CITY OF ALBUQUERQUE

February 8, 2022

RE: **Encanto Apartments
Mesa Del Sol
University Blvd. and Bobby Foster Rd. SE
Grading and Drainage Plan
Engineers Stamp Date 12/27/2021 (R16D101)**

GRADING AND DRAINAGE PLAN
SHEET 2 - SE
ENCANTO APARTMENTS
MESA DEL SOL
DECEMBER, 2021

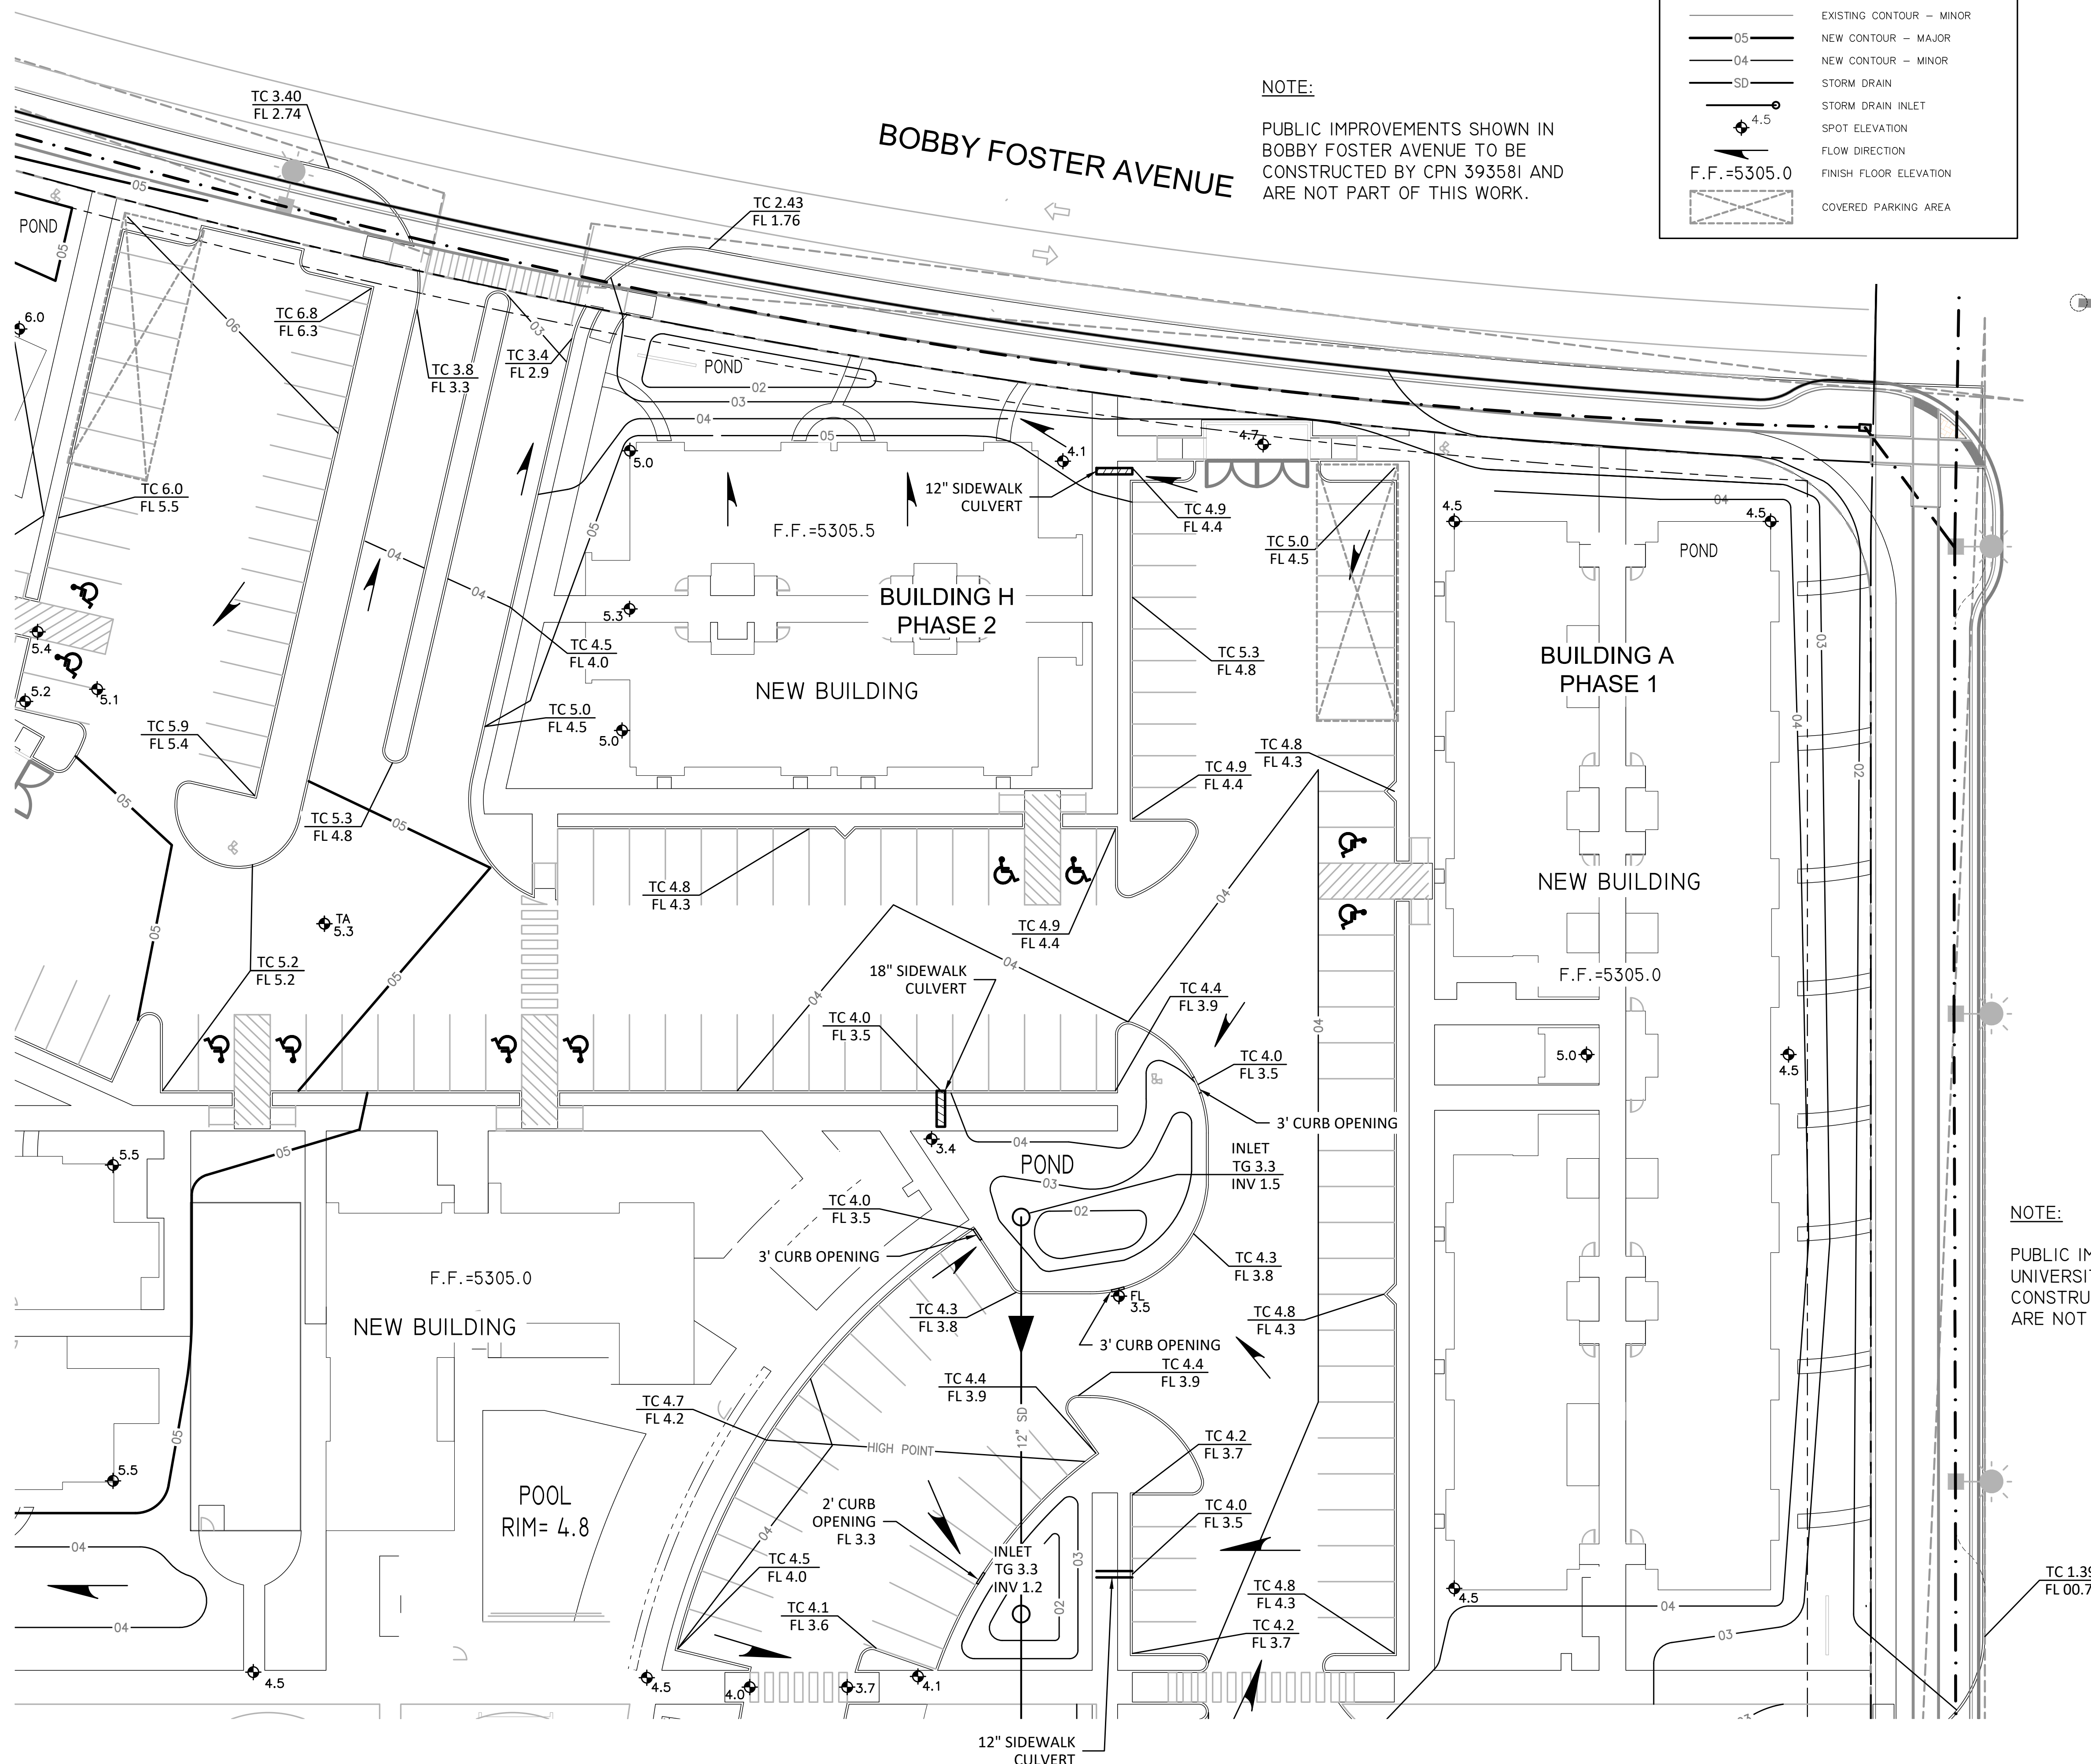
16. On sheet 2 between Buildings B and D there are two ponds connected with an 8" drain line. Based on the diameter and inverts listed, this line looks like it is very shallow. Please check to make sure you have clearance for the sidewalk running above it. Also, the southernmost pond of these two has an inlet with a top of grate elevation higher than the nearby curb opening. This inlet will not capture any flows as designed.

GRADING AND DRAINAGE PLAN
SHEET 3 - SW
ENCANTO APARTMENTS
MESA DEL SOL
DECEMBER, 2021

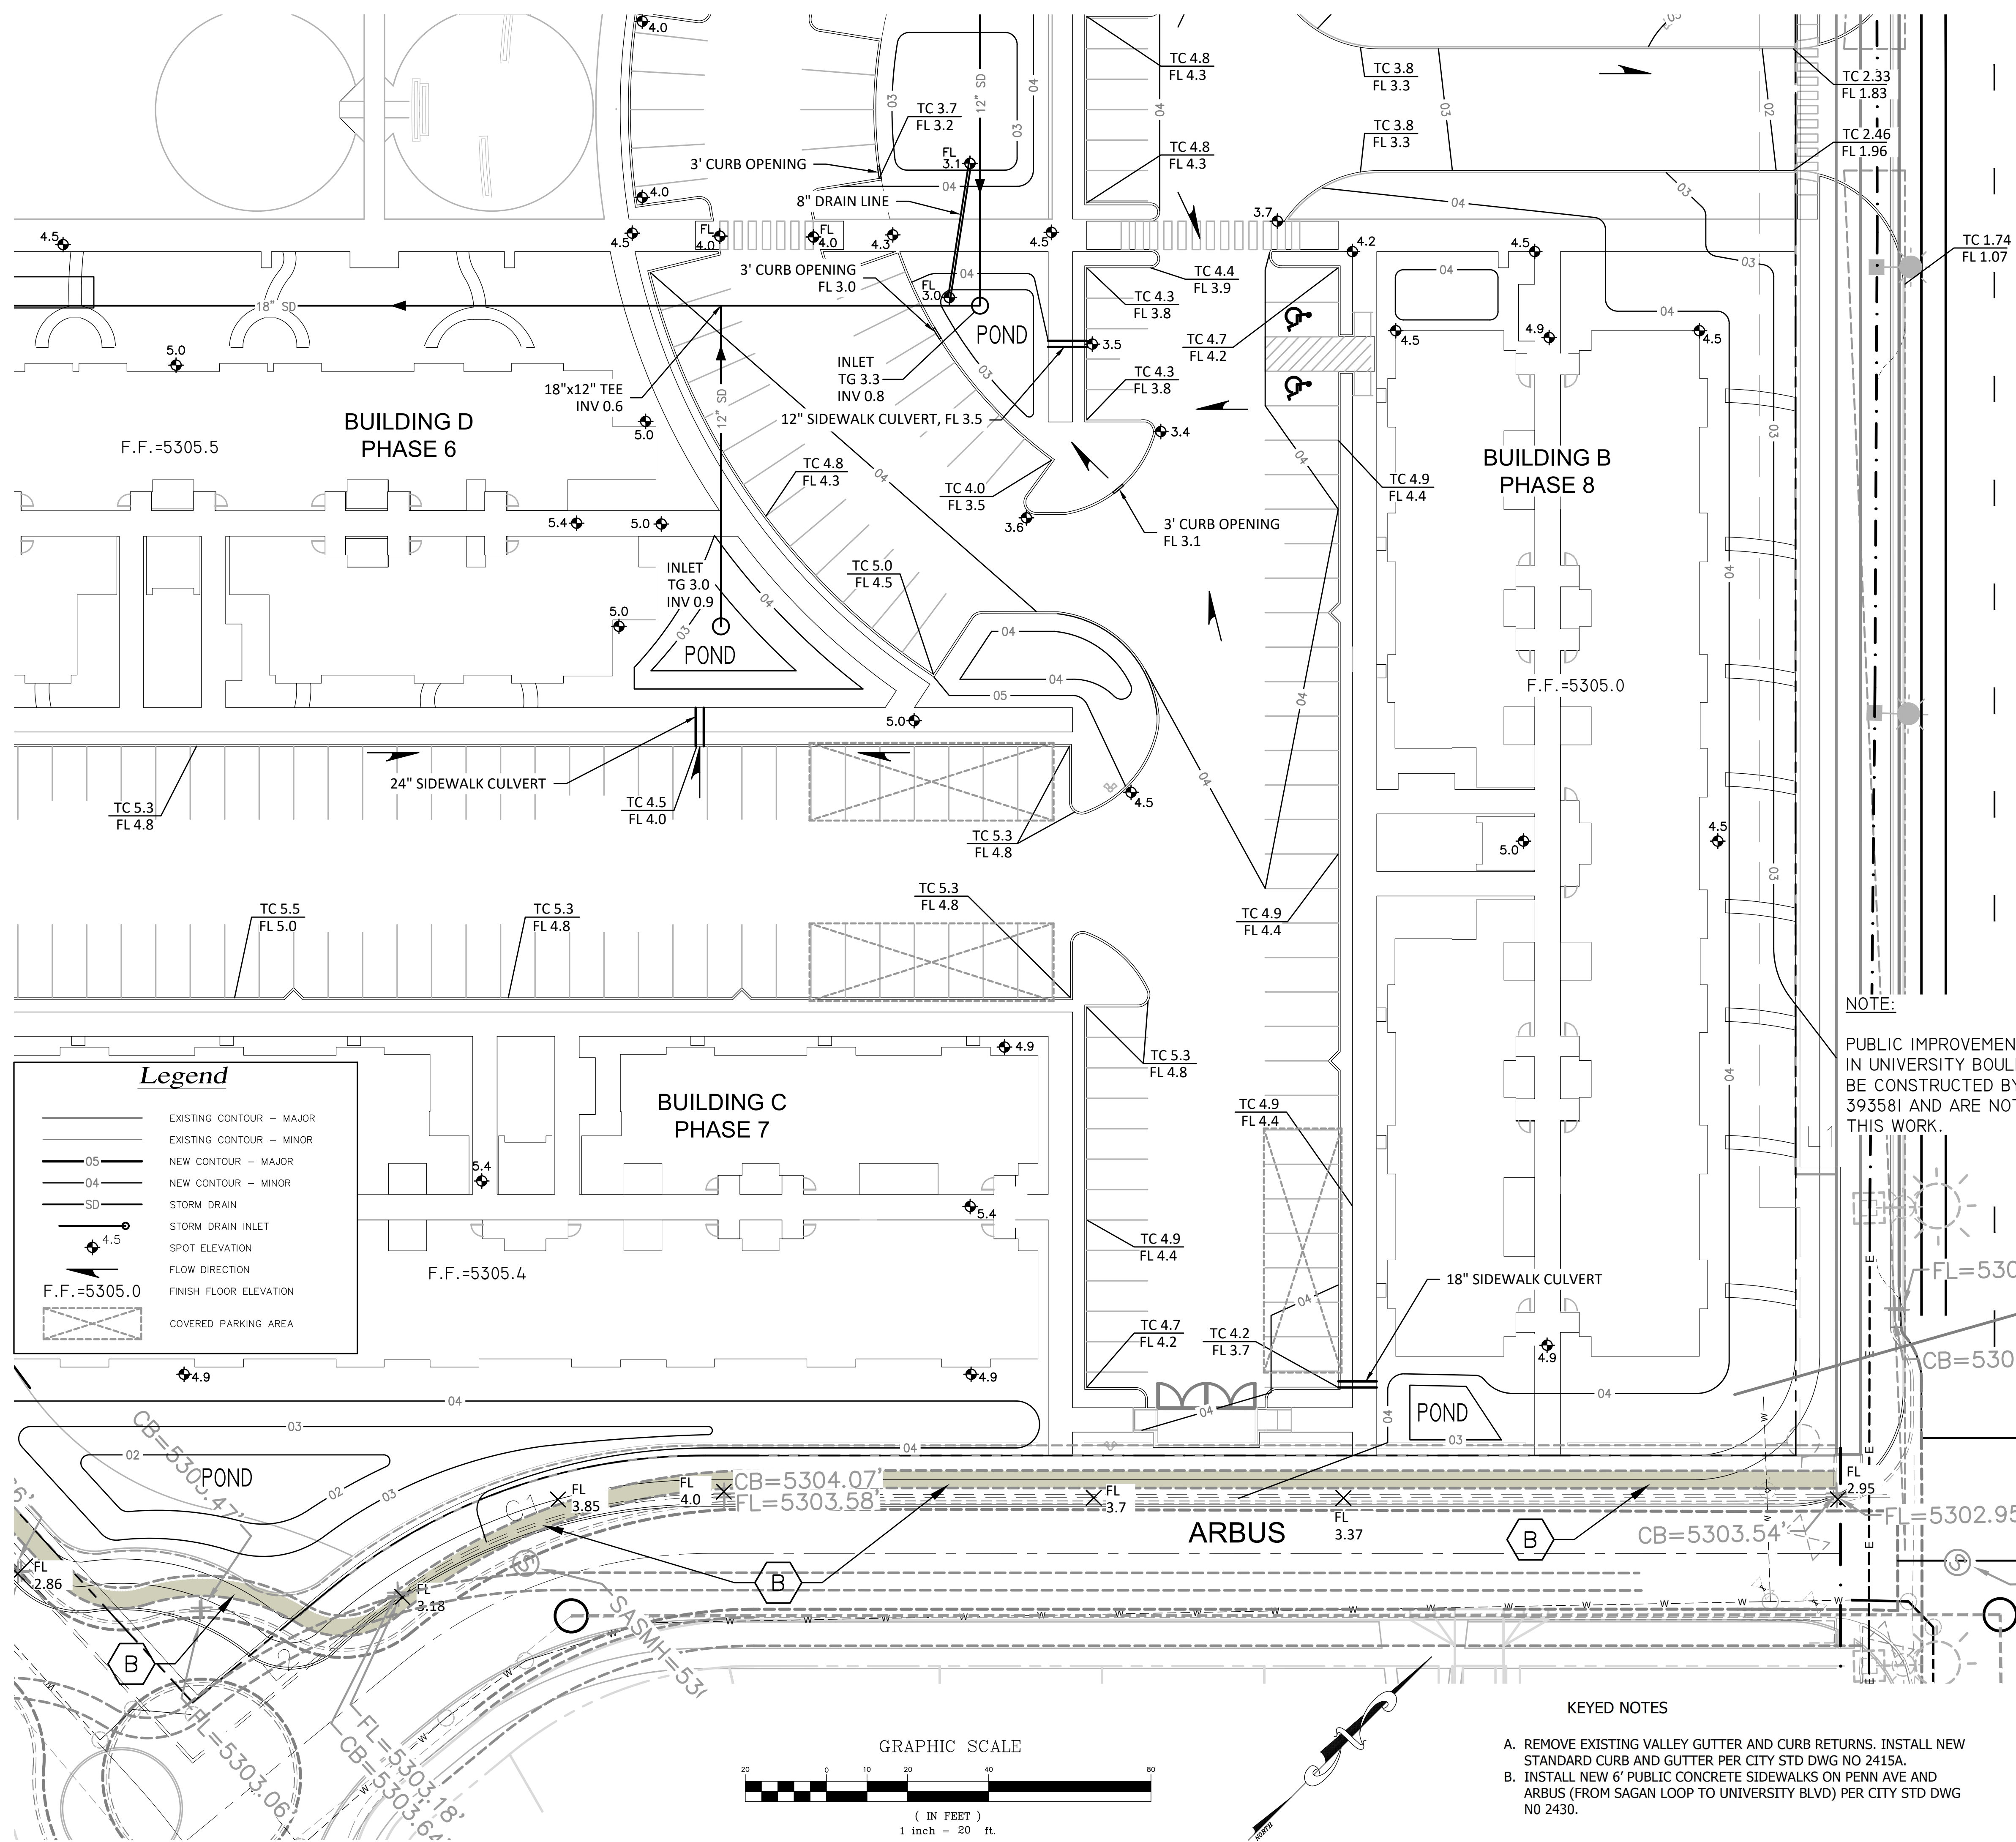
1. In your Drainage Approach you mention the site following historic conditions. The City of Albuquerque does not use historic conditions in site design. All flows must be captured on site or demonstrate downstream capacity if leaving the site.
